**City of Phoenix**  
PLANNING AND DEVELOPMENT DEPARTMENT

**Staff Report Z-54-21-1**  
**November 5, 2021**

**Request To:** C-2 (Intermediate Commercial) (0.91 acres)

**Proposed Use:** Commercial uses within existing building

*Existing Building, Image of South Façade (Cochise Drive Frontage); Source: Image Dated February 2021, Google Streetview.*

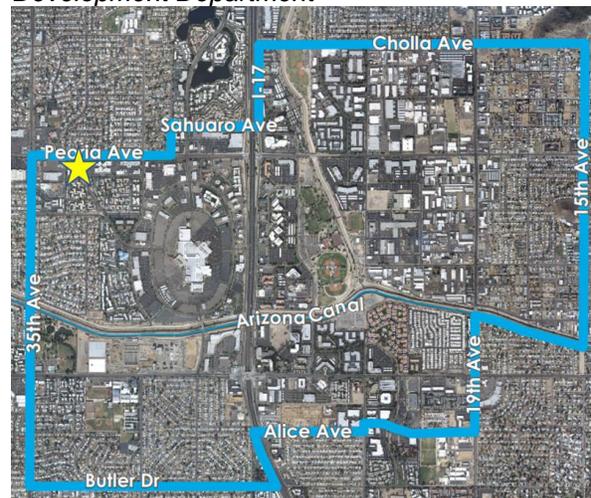
To improve the interface of the site with the street, sidewalk, and other properties fronting on Cochise Drive, staff is recommending

Stipulation No. 1 to require architectural embellishments on the south building elevation oriented to Cochise Drive.

1. The south building elevation shall contain architectural embellishments and detailing such as textural changes, pilasters, offsets, recesses, variation in window size and location, and/or other overhang canopies, as approved by the Planning and Development Department.
